259 Camden High Street
London, NW1 7BU

Basement Impact Assessment
Audit

For
London Borough of Camden

Project Number: 12336-51
Revision: D2

CONSTRUCTION SEQUENCE
251-259 CAMDEN HIGH STREET.
4352/SK/160520/TKL/00

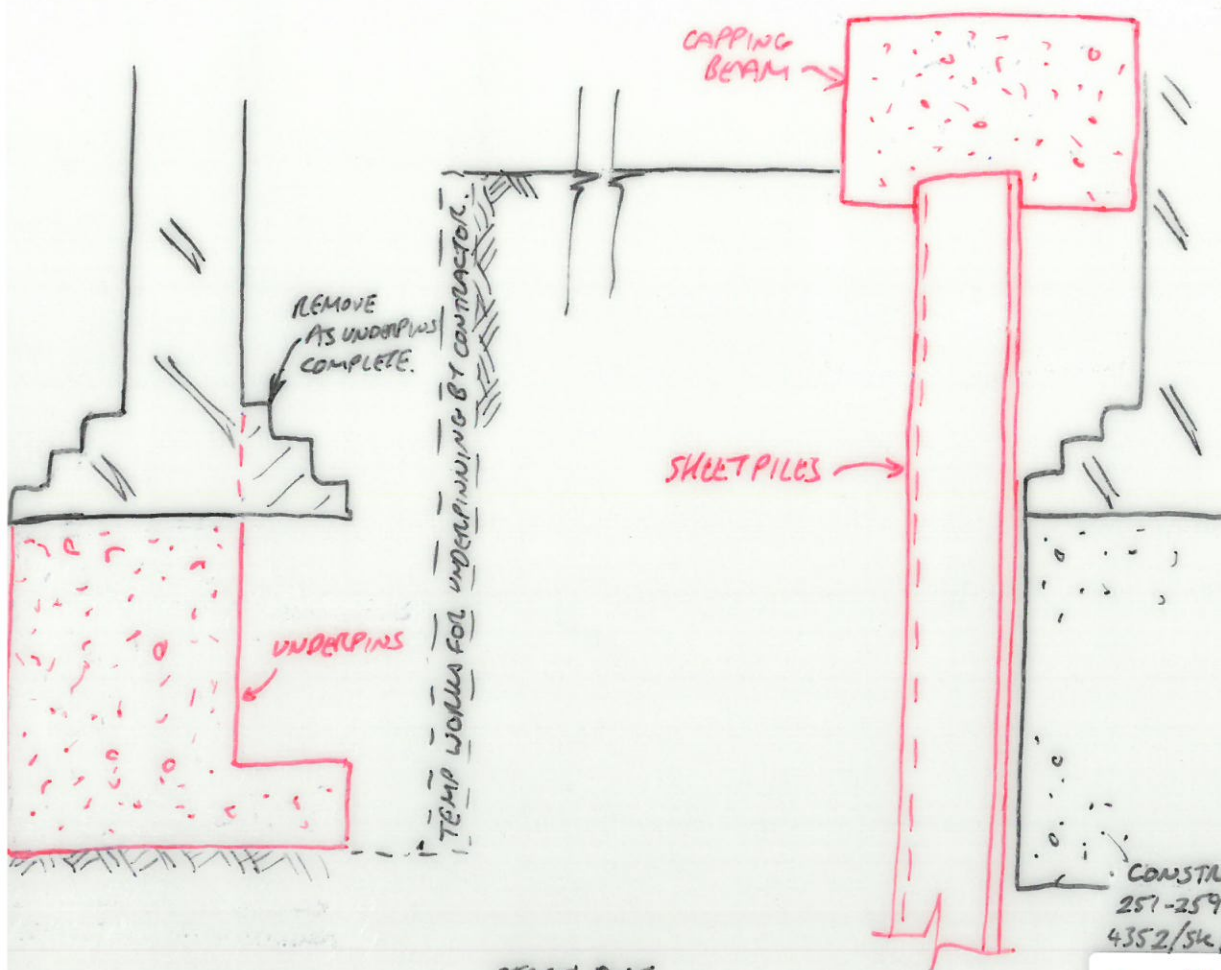
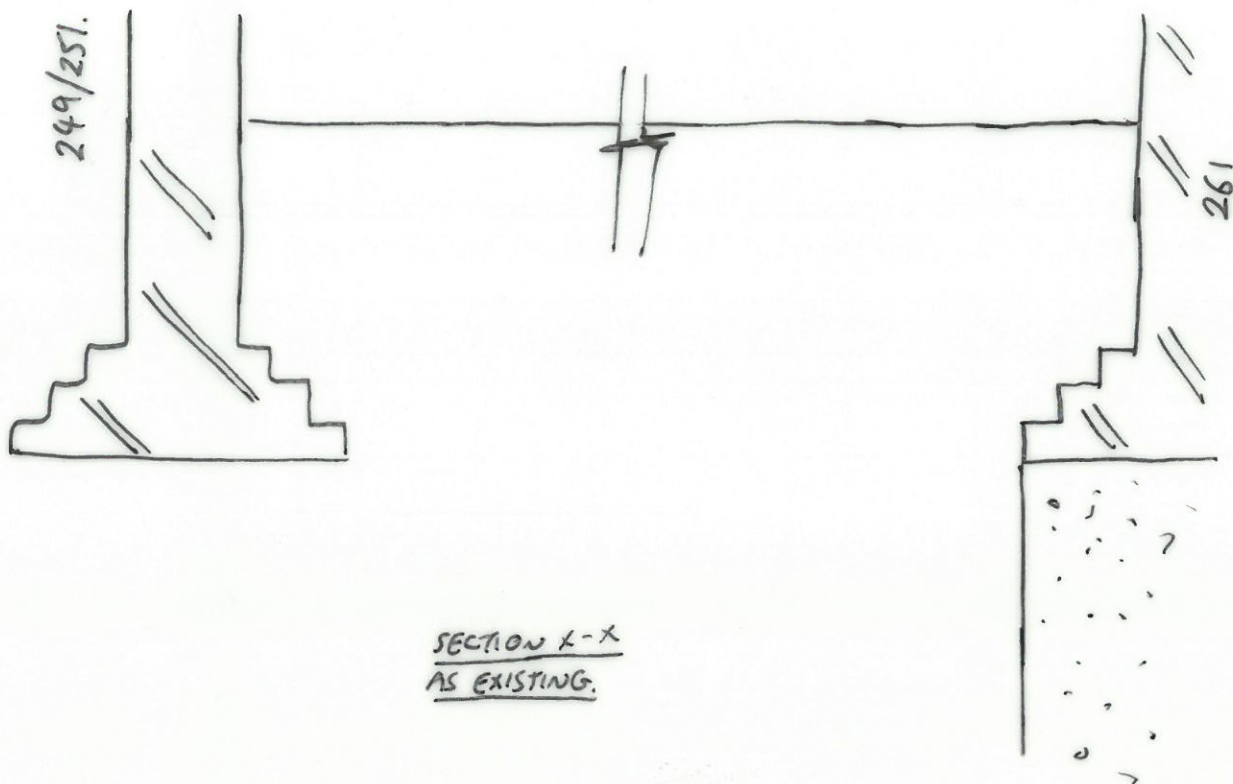
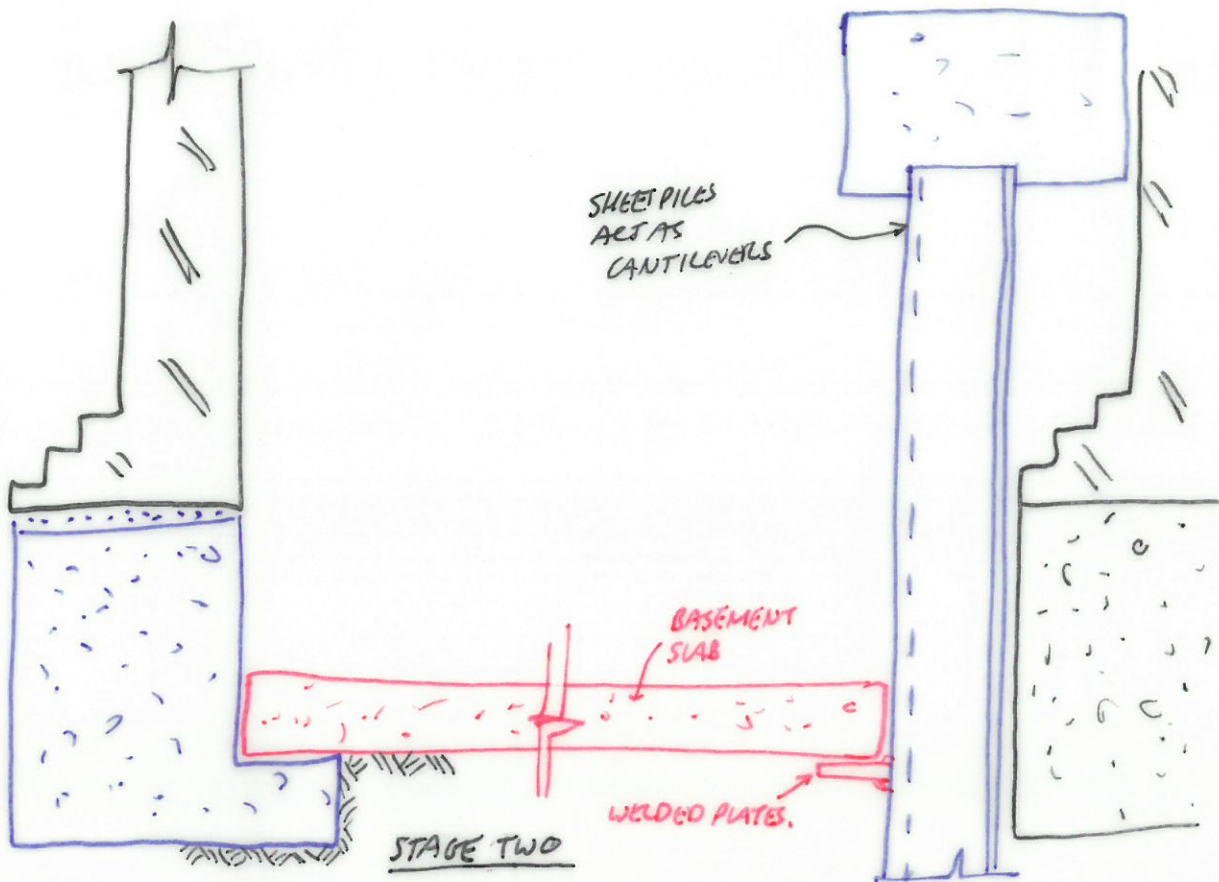
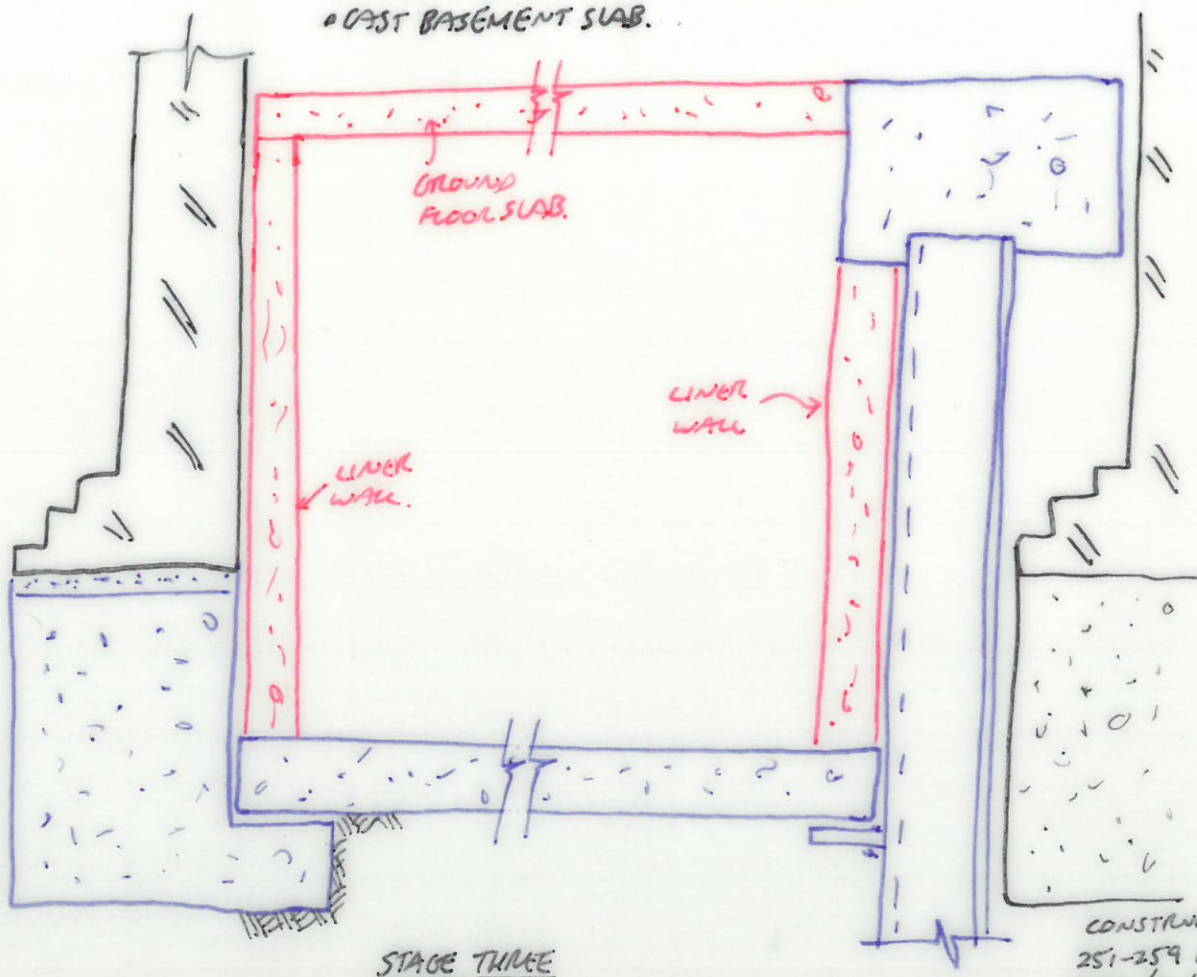
- 4.11. Reference is made to structural design by the engineers Walsh Associates. Suitable outline discussions on construction methodology and recommendations for undertaking underpinning is provided in the BIA, along with outline sketches (see Appendix 3). Detailed methodology, sequencing and propping arrangements should be presented in a BCP.
